ETROC2 Minor Modifications (at metal layer 2)

Sep. 11, 2023

Outline of R2 minor modifications at metal layer 2

Proposed simple solution

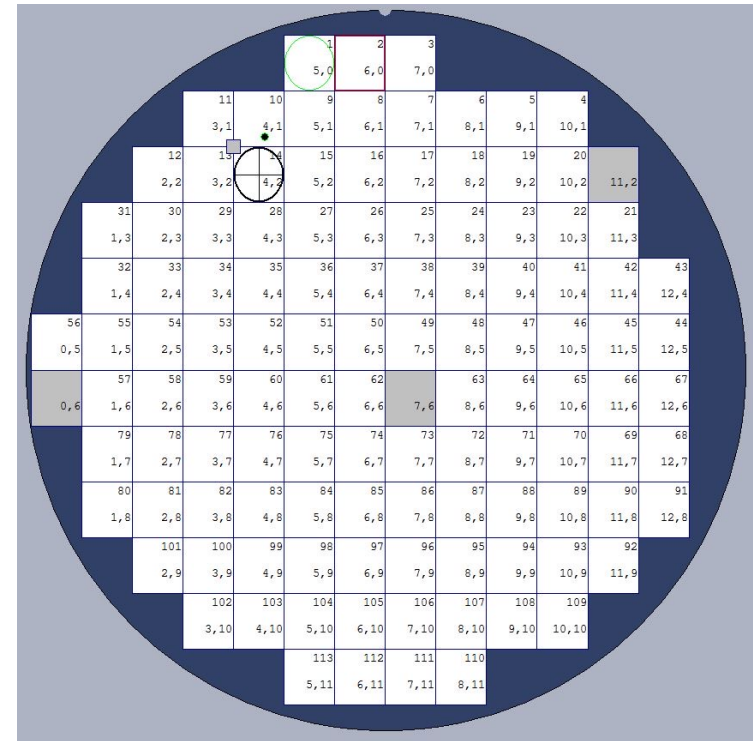
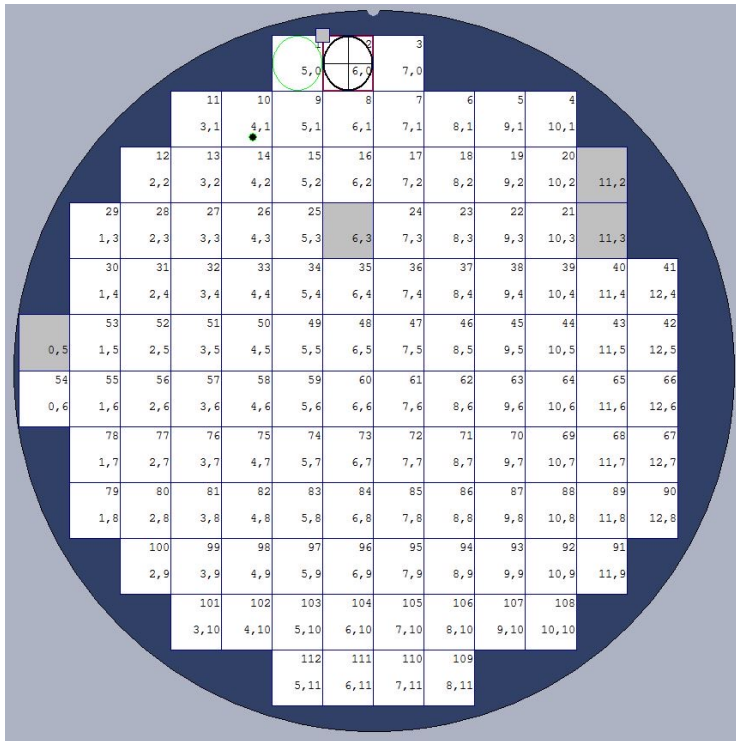
- The proposed solution is connecting the shielding structures to the digital ground by only updating M3 without modifying other sections, even no via added and no chip dummy fill modified.
- All M3 parts should have a connection to OD ground without going through high metals, such during production, the M3 always has a discharge path

Diagram of Vref distribution and layout connection

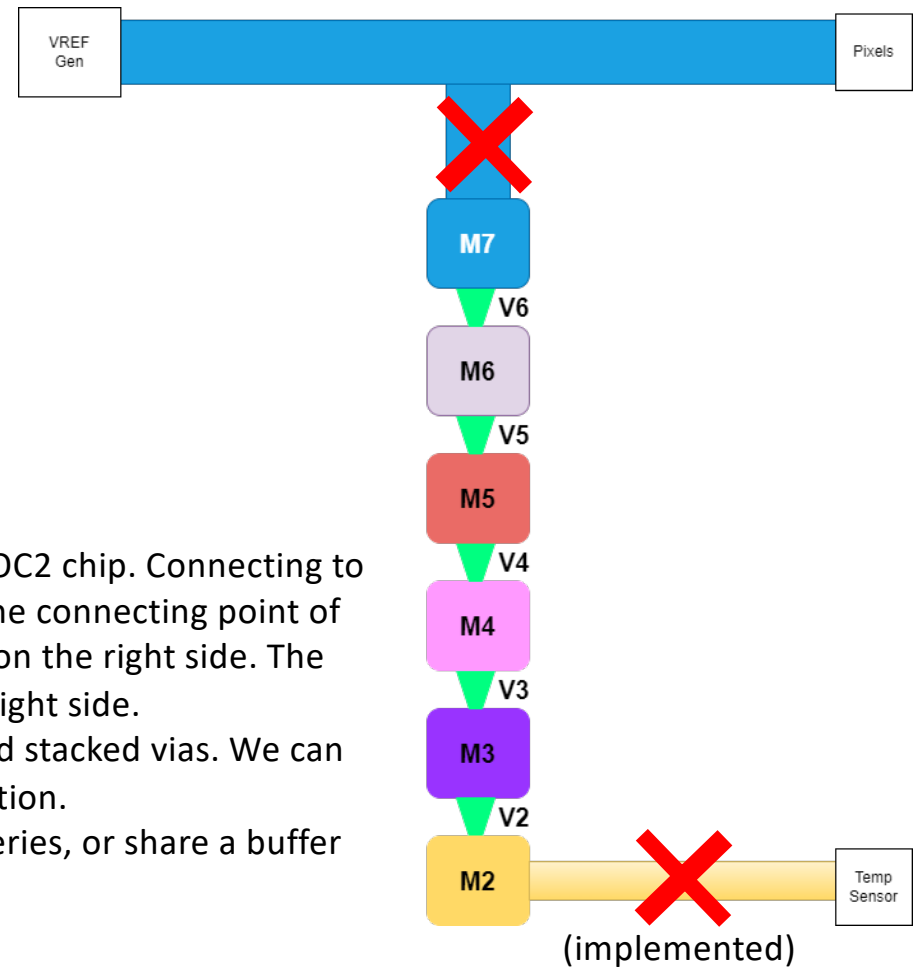
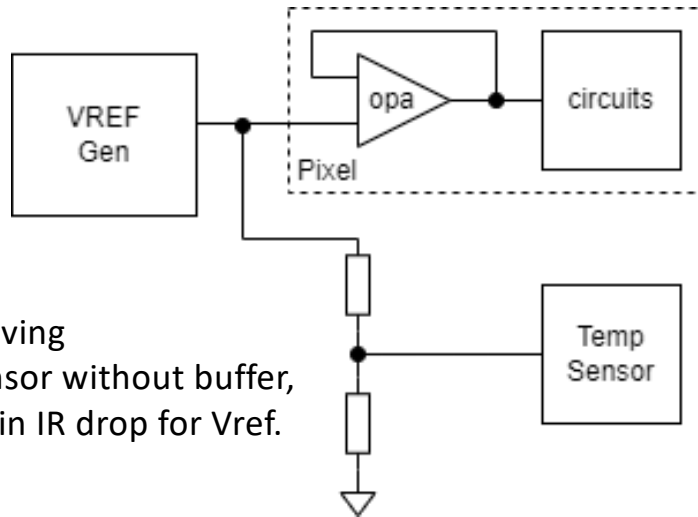
Vref is driving
Temp Sensor without buffer,
resulting in IR drop for Vref.

- The VREF generator is in the lower left part of the ETROC2 chip. Connecting to the wide and horizontal metal layer to each column. The connecting point of the wide metal 7 and the Vref input of Temp sensor is on the right side. The cross section of the connecting point is shown on the right side.
- Since the connection using metal layer M7 and M2, and stacked vias. We can cut either metal 7 or metal 2 to disconnect the connection.
- In ETORC3, we can insert a buffer before the resistor series, or share a buffer from one pixel (0, 0) to address this issue.

Possible solutions for WS floating ground

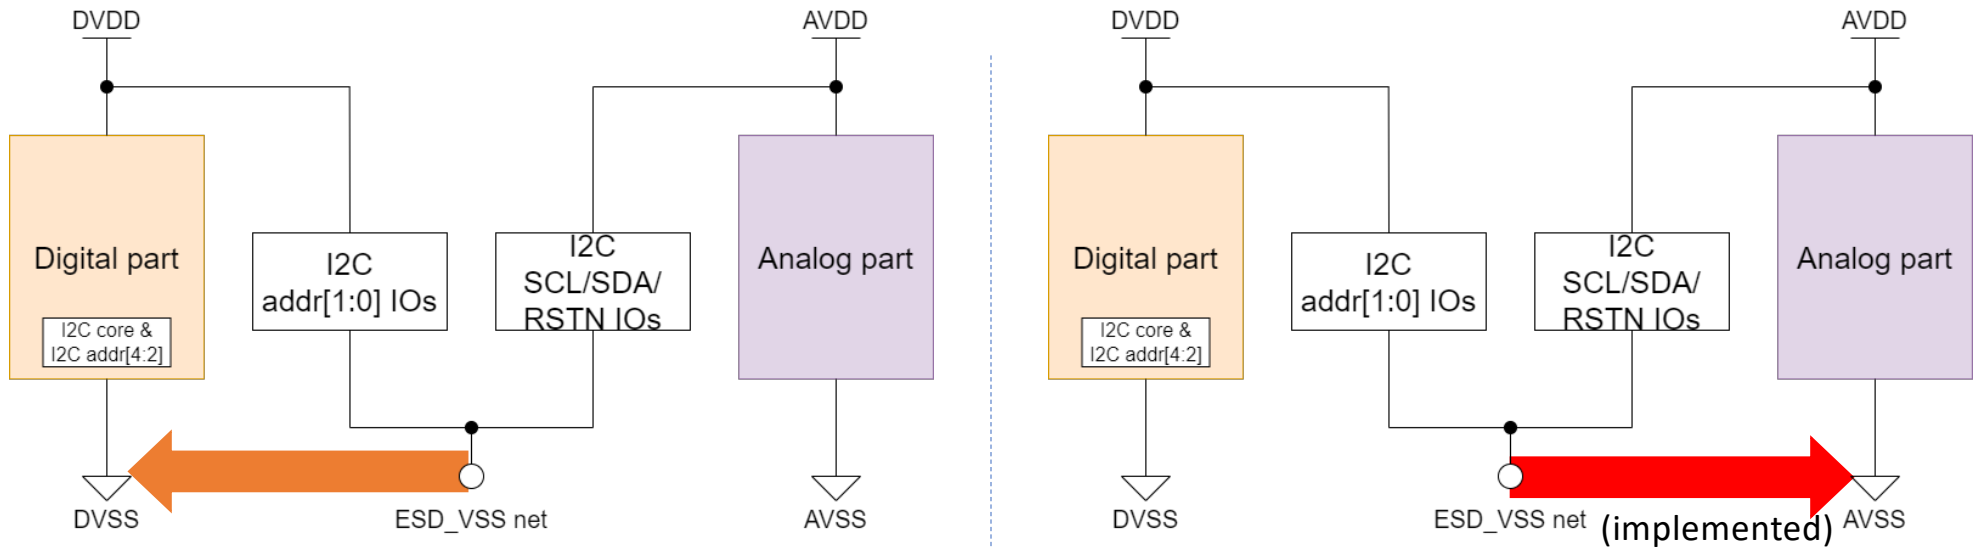
- Left diagram shows to connect the ESD_VSS net to the digital ground (DVSS). This solution can be done from metal layer 3 to 6.
- Right diagram shows to connect the ESD_VSS net to the analog ground (AVSS). This solution can be implemented from metal layer 2 to 6.

Possible solutions for Efuse clock selection

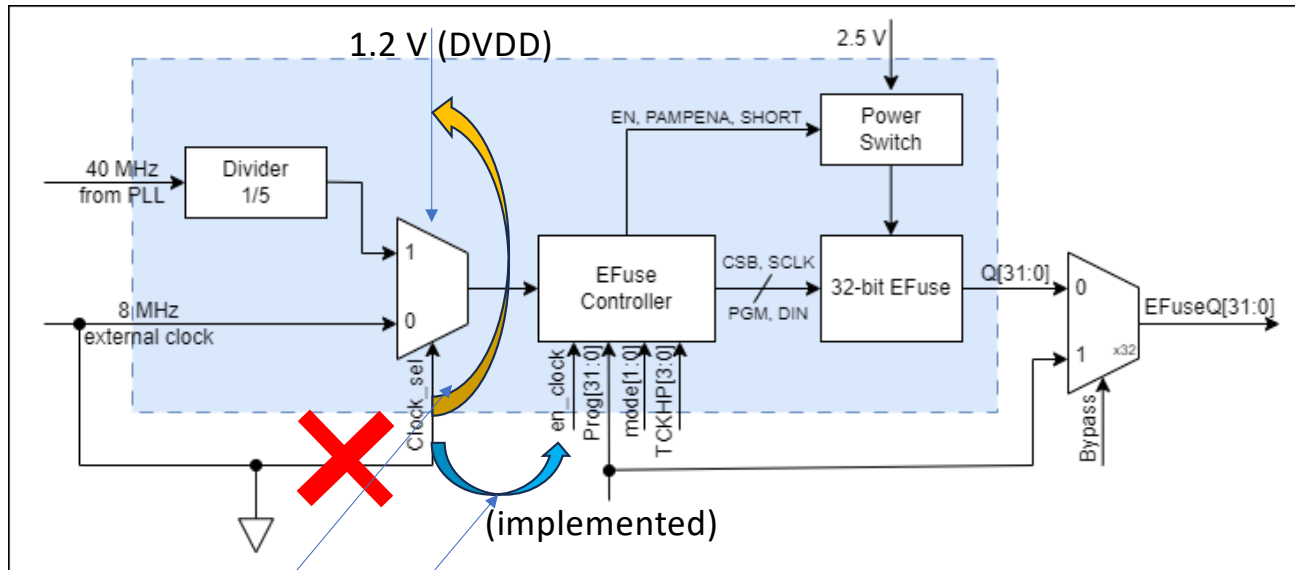
- Disconnect the connection of Clock_sel to the ground (Low), and connect Clock_sel to digital power (DVDD). The Clock_sel will be fixed as logic high to select the internal clock.
- Disconnect the connection of Clock_sel to the ground (Low), and connect Clock_sel to en_clock. En_clock is controlled by I2C, which means if en_clock is enabled (active high), the input clock is using the internal clock. If en_clock is disabled, the clock mux will select external input (ground) which will save power consumption.
- The modifications can be done on metal layer 2.

Possible solution for EFuse

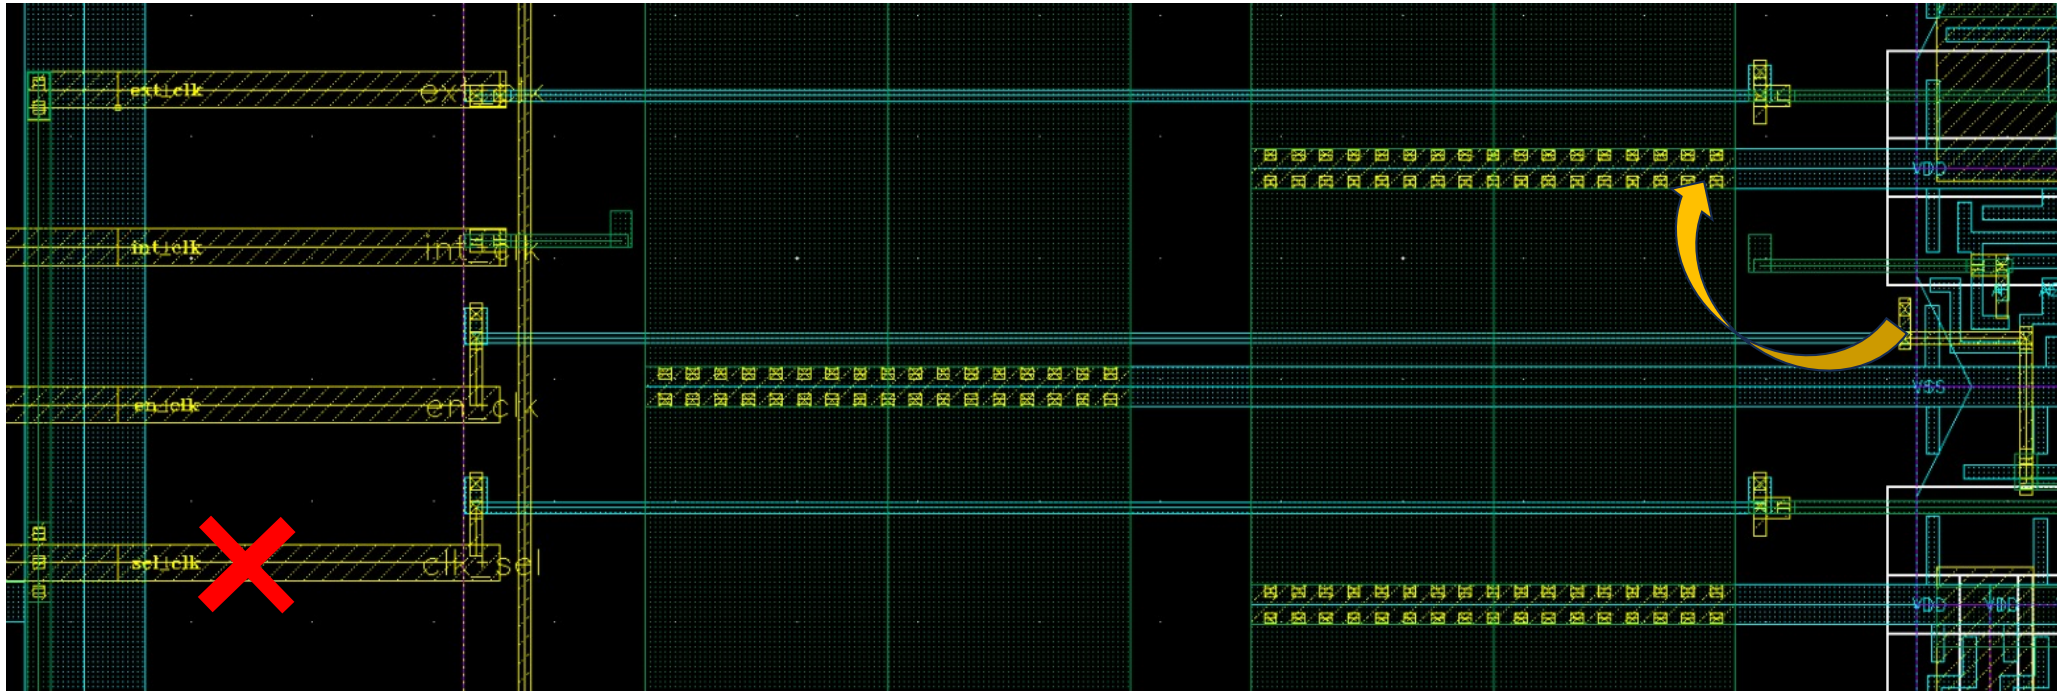
- Disconnect the connection of Clock_sel to the ground (Low), and connect Clock_sel to digital power (DVDD). The Clock_sel will be fixed as logic high to select the internal clock.

Possible solution for Efuse (implemented)

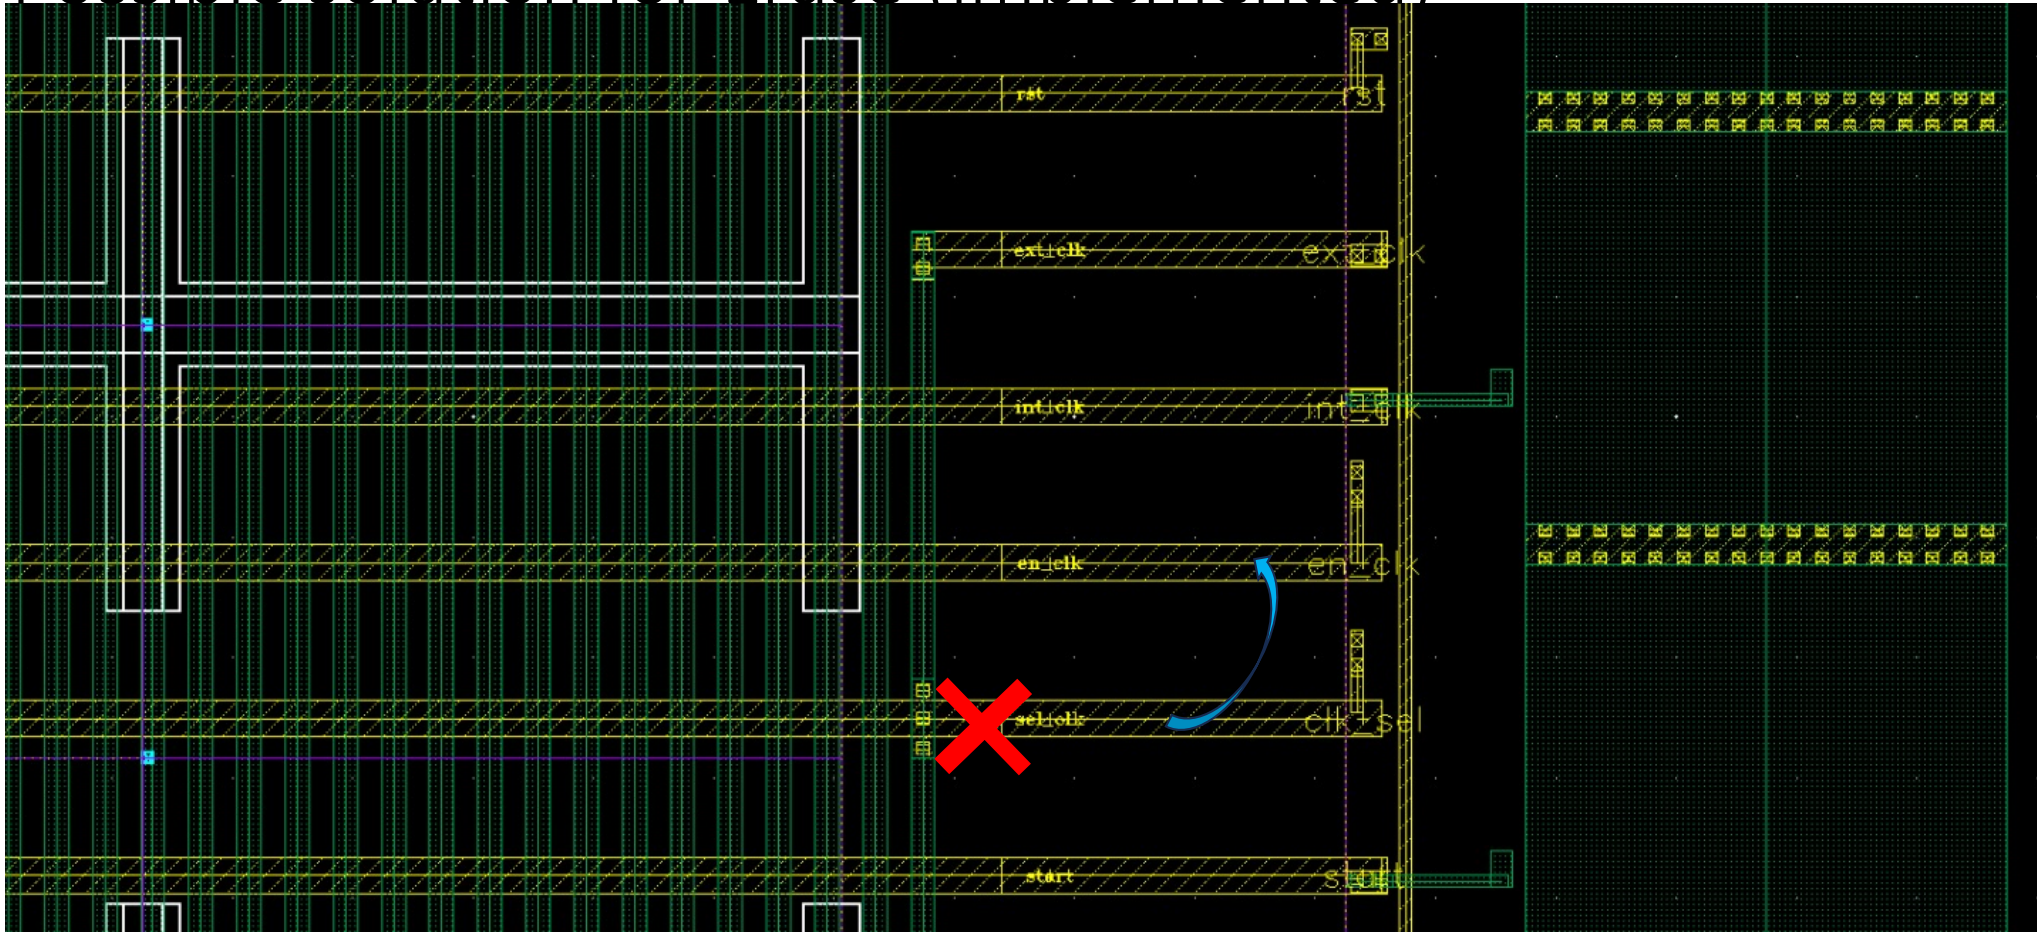
- Disconnect the connection of Clock_sel to the ground (Low), and connect Clock_sel to en_clock. En_clock is controlled by I2C, which means if en_clock is enabled (active high), the input clock is using the internal clock. If en_clock is disabled, the clock mux will select external input (ground) which will save power consumption.
